NMED/DOE/AIP-94/3

Review of Ground-Water Monitoring at Sandia National Laboratories' Mixed Waste Landfill

AIP/DOE Oversight Group
Hazardous and Radioactive Materials Bureau
New Mexico Environment Department
P. O. Box 26110
Santa Fe, New Mexico 87502

March 1993

Figure 1. Map of Mixed Waste Landfill showing monitor wells, trenches, and waste pits (modified from Anonymous, 1991).

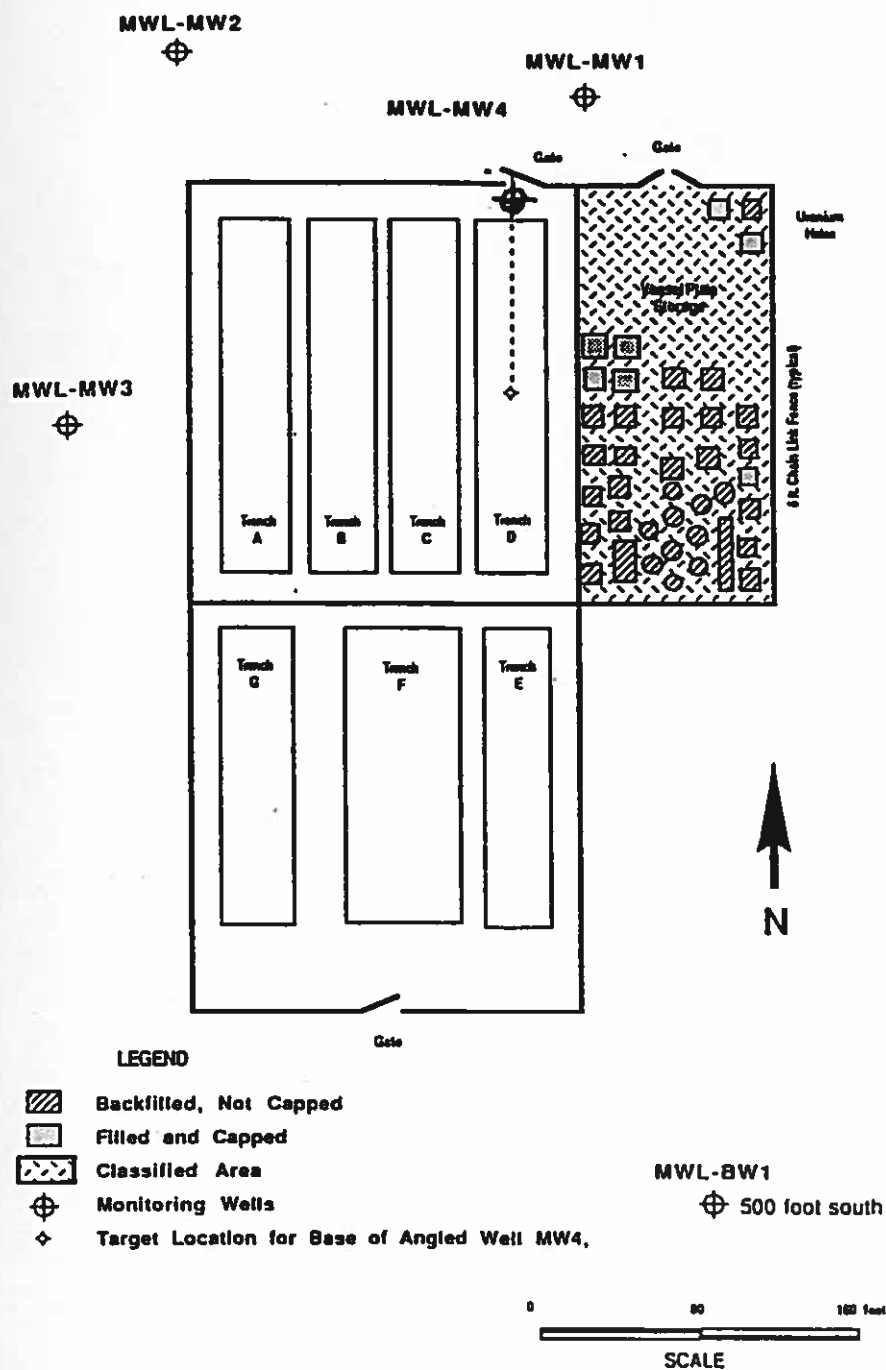
A total of five ground-water monitor wells have been installed at the MWL (Figure 1). A fairly detailed report describing the installations of monitor wells MWL-MW2, MWL-MW3, and MWL-BW1 was prepared for SNLA by Ecology and Environment, Incorporated (Anonymous, 1989). This same report also describes the installation of MWL-MW1, which was drilled similarly and at about the same time period as the 1988 CWL monitor wells. The first well, MWL-MW1, was installed at the MWL in 1988 by air-rotary casing-driven drilling methods. Monitor wells MWL-MW2, MWL-MW3, and MWL-BW1 were completed by September 1989 using mud-rotary drilling (Anonymous, 1989). In general, installation of the latter three wells consisted of drilling exploratory pilot holes for soil sampling and geophysical logging, followed by reaming of the pilot holes to facilitate construction of the wells.

Although monitor wells MWL-MW1, MWL-MW2, MWL-MW3, and MWL-BW1 generally meet the requirements of EPA guidance, well construction diagrams show that the primary filter packs of MWL-MW2 and MWL-MW3 extend about five feet below their well screens (Anonymous, 1989). U. S. Environmental Protection Agency (EPA) guidance suggests that a "filter pack should generally extend from the bottom of the well intake to approximately 2 to 5 ft above the top of the well intake provided the interval above the well intake does not result in cross-connection with an overlying zone" (Allen and others, 1991).

1. Monitor well MWL-MW4 will not prevent unavoidable random errors associated with Depth-to-Water (DTW) measurements. Although DTW averages about 460 ft, wells MWL-MW1, MWL-MW2, and MWL-BW1 have static water levels which typically differ by only 0.1 foot or less. Even with well casing deviation surveys, errors in DTW measurements will likely exceed the differences in static water levels between monitor wells. Thus, it is doubtful that the horizontal direction and gradient of ground-water flow can be reliably determined using the existing monitor well network, even with the addition of MWL-MW4. Additional monitor wells will have to be installed at the MWL which are located at greater distances from the landfill to adequately resolve this problem.

3. In Anonymous (1991), there is no mention of any mechanism in the design of MWL-MW4 to separate the lower from the upper screened intervals. The two intervals must be separated during ground-water sampling. If ground-water contamination is found in MWL-MW4, the monitoring intervals should be isolated at all times to prevent cross-contamination between shallow and deeper ground water.

4. The total design length of the primary and the secondary filter packs for MWL-MW4 is 65 feet. The two screened intervals have a combined length of 40 feet. As mentioned previously, EPA guidance suggests that filter packs should not extend more than 2 to 5 feet above their screened intervals (Allen and others, 1991). To the extent possible, filter packs should coincide with their respective screened intervals to minimize potential dilution of water quality samples. Because the screened intervals of all MWL wells are already relatively large for monitoring purposes (equal to or exceed 20 feet), the extension of filter packs above the well intakes for any new wells constructed at the MWL should be limited to no more than 5 feet. A secondary filter pack can be substituted as part of that 5 feet extension to prevent contamination of the primary filter pack by grout or bentonite/volclay seals.
